Flight Procedures Cover Page	Task Action: FLIGHT CHECK	Task Type: Route	Estimated Chart Date: 08/10/2023	APWS Task ID: F0FA5794D90D4DCA9D62C72FEF24251C	APWS Project ID: F075672C86E24EA3A9DAC179B8B4BA75
Procedure: ZK411 GUNTY, ME TO IDATE, ME		Enroute: YES	Specialist: Damron, Todd		Agreement Number:
Airport ID:			Airport City:		State:
Facility ID:	Facility Type:	Flight Inspection Remark Type: Hold FC Slot			
<p><b>Procedure Comments:</b>  AIRWAY STARTING POINT: ZK411 GUNTY, ME TO EDGUE, ME. 432924.30N/0702919.48W  SPECIAL LOW LEVEL RNAV HELICOPTER ROUTE; SUPPORT FOR LOM AIR AMBULANCE OPERATIONS.  POC FOR THIS MATTER: ALLAN WILL 405-954-6103.</p> <p>01/10/23: THIS IS AN UPDATED COPY OF THE FORM DEVELOPED ON 11/15/22.  8260-16  **SEGMENTS: GUNTY TO BRNDI; BRNDI TO TOBKE; TOBKE TO SATLY -- SEGMENT REMARKS: ADDED REASON FOR GNSS MEA VALUE, GREATER THAN MRA AND MOCA.  **SEGMENT: SATLY TO ADILE -- 1. FIX TUSSL REPLACED WITH FIX ADILE DUE TO TUSSL BEING A DUPLICATE ATC FIX. 2. SEGMENT REMARKS: ADDED REASON FOR GNSS MEA VALUE, GREATER THAN MRA AND MOCA.  **SEGMENT: ADILE TO MARSY -- 1. FIX TUSSL REPLACED WITH FIX ADILE DUE TO TUSSL BEING A DUPLICATE ATC FIX. 2. SEGMENT REMARKS: ADDED REASON

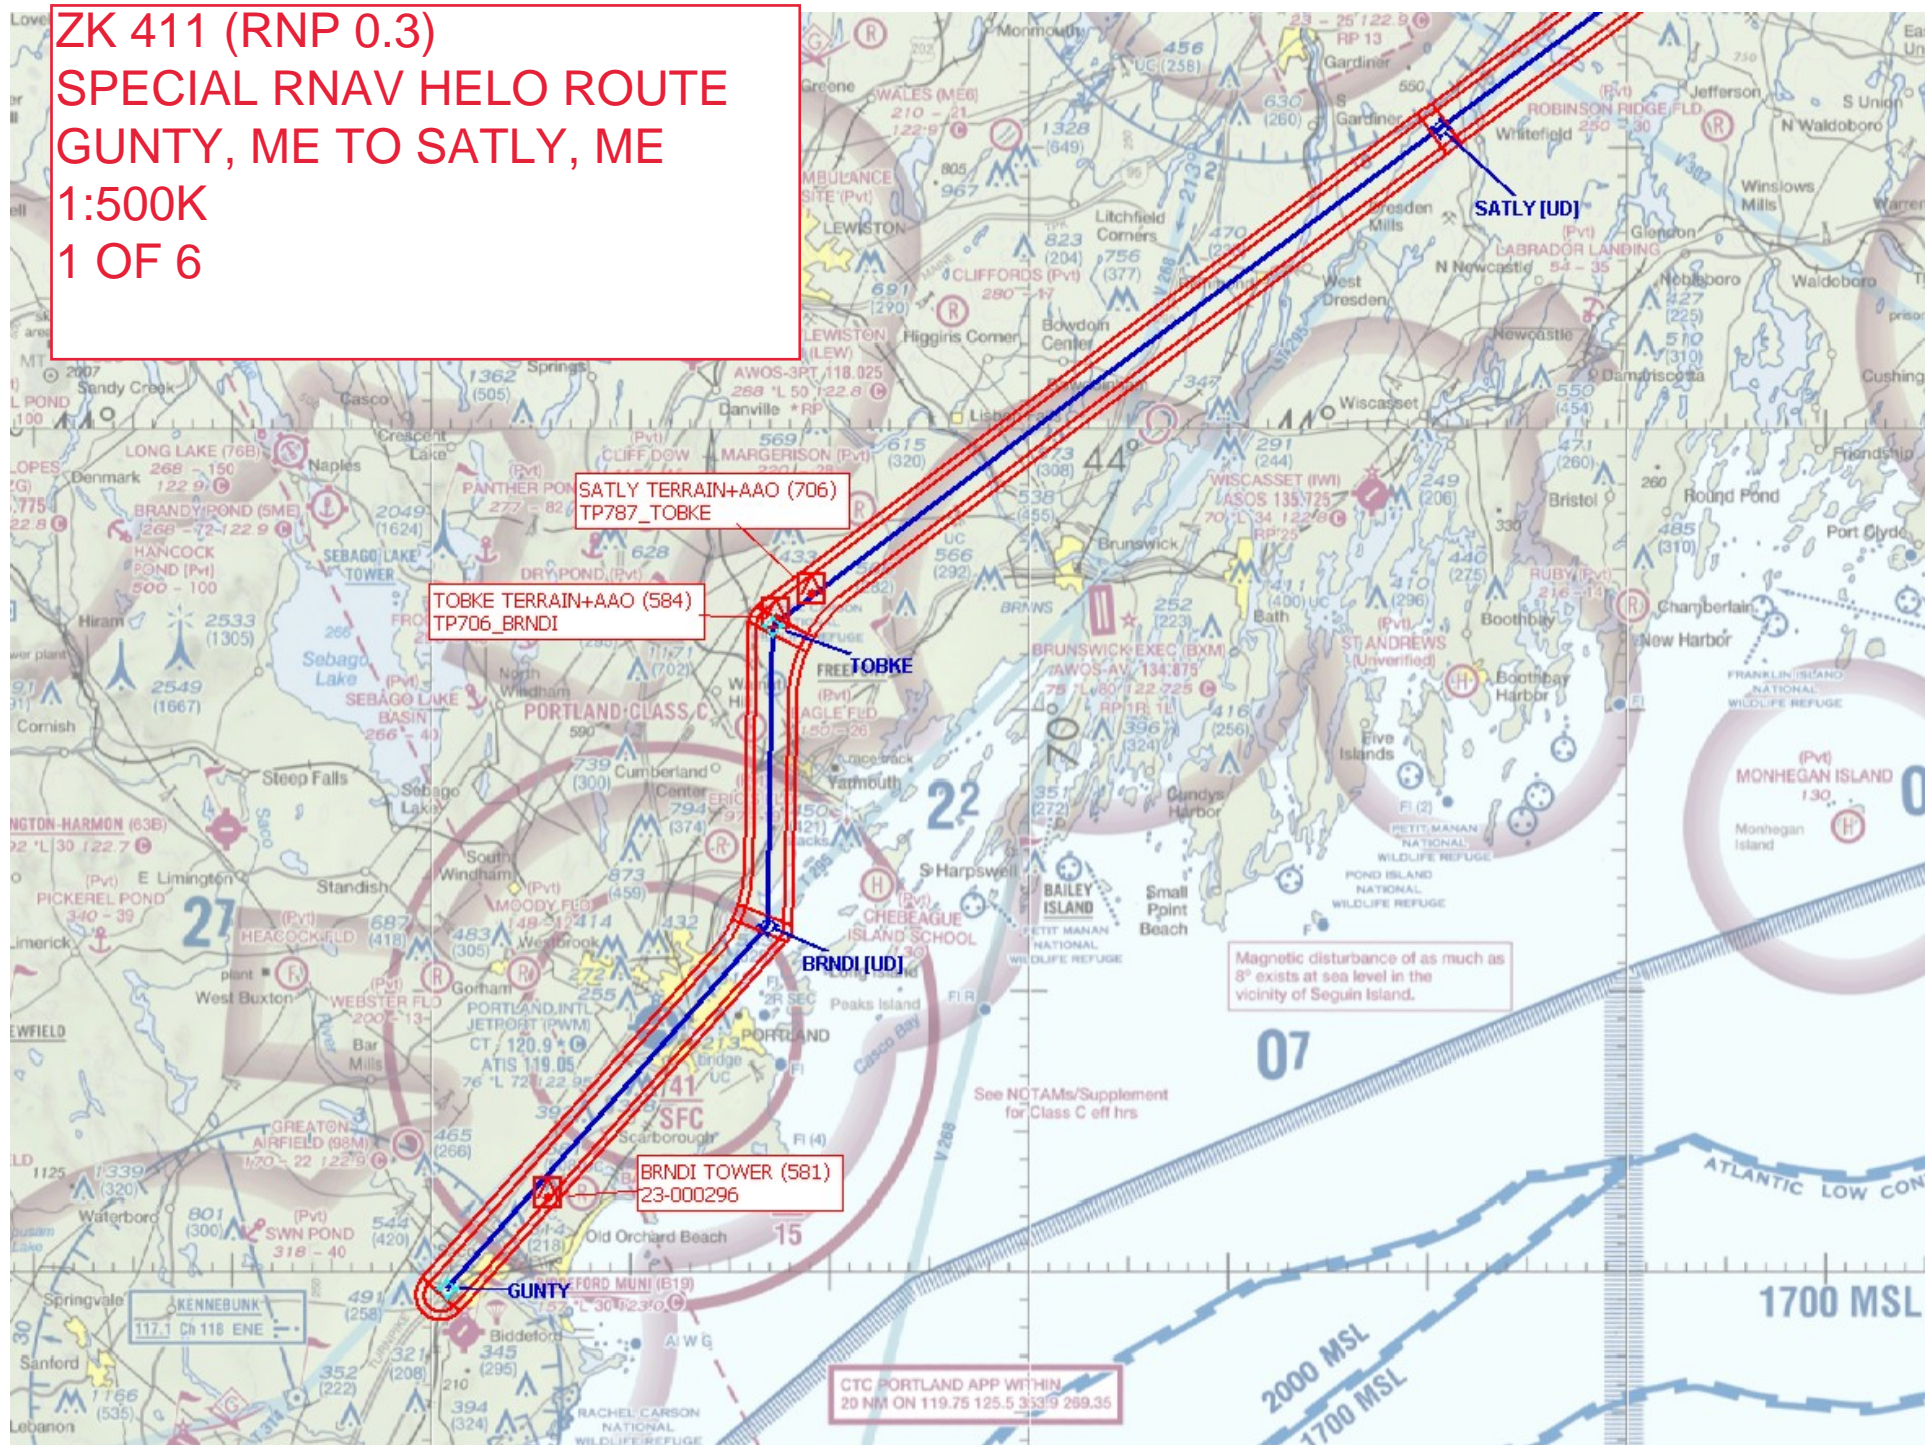
<b>FLIGHT INSPECTOR SIGNATURE:</b> kevin riese @ 05/22/2023 18:49			<b>PRINTED NAME:</b> RIESE, KEVIN JOHN			<b>NOTAM INITIATED?</b> <input type="checkbox"/> YES <input checked="" type="checkbox"/> NO	
<b>FLIGHT INSPECTOR REMARKS:</b> ZK 411 helicopter low level route SAT as proposed. Recommend to replace EDGUE POINT WITH IDATE. Both points are on the ME48 COPTER RNAV (GPS) 002 approach. The ZK 411 route arrives at 3300 feet to IAP for the approach at EDGUE, then required to climb to 4600 feet. Suggest terminating route at IDATE at 3300 feet, then amend ME48 approach to make it a IAP straight in or holding pattern type arrival at 3300 feet.							
<b>IN-FLIGHT OBSTACLE REPORT</b>							
<b>OBSTRUCTION ID #:</b>	<b>COORDINATES OR LOCATION:</b>		<b>GNSS ALTITUDE (MSL):</b>		<b>BAROMETRIC ALTITUDE (MSL):</b>		<b>HEIGHT ABOVE GROUND LEVEL:</b>
